# Product Change Notice (PCN)

PCN Number: PCN-0450260R-01

**Product(s) Affected:** MD-SM series (part numbers MD-30SM, MD-40SM, MD-50SM, MD-60SM, MD-70SM, MD-80SM, MD-90SM).

# New Design (MD-30SM, MD-40SM, MD-50SM, MD-60SM, MD-70SM, MD-80SM)

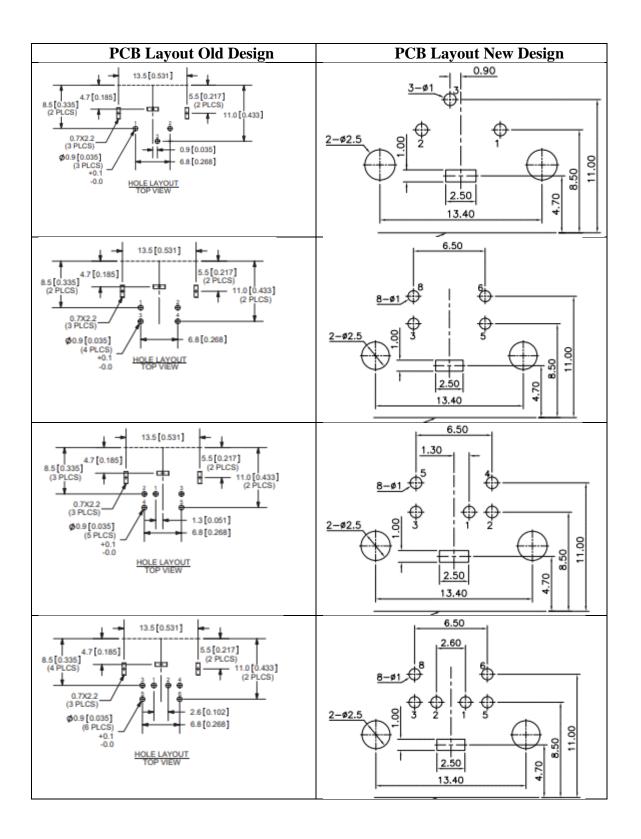
**Description of Change:** minor dimensional changes, as shown below.
